Access Compliance Report

Public Rights-of-Way

(Curb Ramps)

Intersection ID: 43739	Main Street: BRIDGEMOUNT_AV	Cross Street: BRIDGEVIEW_LN	Location: SE
ADA ID: 5DB575D018C6	Ramp Type: PerpDiag	Initial Pass/Fail: Fail	Overall Compliance: No
Severity Score: 21.25			
Codes/Mitigation Info/Possible Solution		Field Measurements/Component Compliance

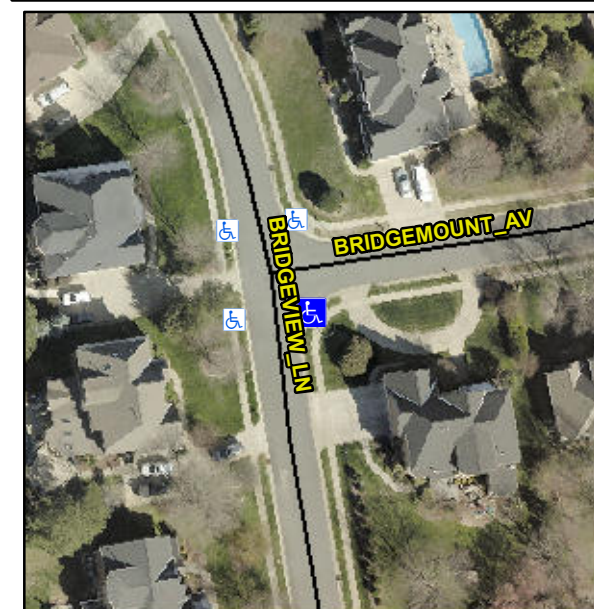
Not Found, R304.5.1, R304.2.2

Compliance	Description	Data	Compliance	Description	Data
N/A	Ramp Length (in)	48.0	No	Ramp Slope (%)	9.7
No	Ramp Width (in)	41.0	Yes	Ramp XSlope (%)	0.5
N/A	Flare Type LT	N/A	N/A	Flare Type RT	N/A
N/A	Flare Slope LT (%)	N/A	N/A	Flare Slope RT (%)	N/A
N/A	Flare Traversable LT?	N/A	N/A	Flare Traversable RT?	N/A
N/A	Landing Length (in)	N/A	N/A	DWS Provided?	N/A
N/A	Landing Width (in)	N/A	N/A	DWS Contrast?	N/A
N/A	Landing Slope (%)	N/A	N/A	DWS Length (in)	N/A
N/A	Landing X Slope (%)	N/A	N/A	DWS Full Width?	N/A
N/A	Landing Curb? (Y/N)	N/A	N/A	DWS Offset (in)	N/A
N/A	Shared Landing?	N/A			
N/A	Gutter Ponding?	N/A	N/A	Gutter Slope (%)	N/A
N/A	Gutter Lip Ht (in)	N/A	N/A	Gutter X Slope (%)	N/A
N/A	Painted X Walk1?	No	N/A	Painted X Walk2?	No
	X Walk 1 Direction	To N		X Walk 2 Direction	To W
N/A	X Walk 1 Width (in)	N/A	N/A	X Walk 2 Width (in)	N/A
	X Walk 1 Slope (%)	0.3		X Walk 2 Slope (%)	1.8
	X Walk 1 X Slope (%)	0.1		X Walk 2 X Slope (%)	0.9

Remove & Replace Curb Ramp With Two New Directional Ramps or Equivalent.
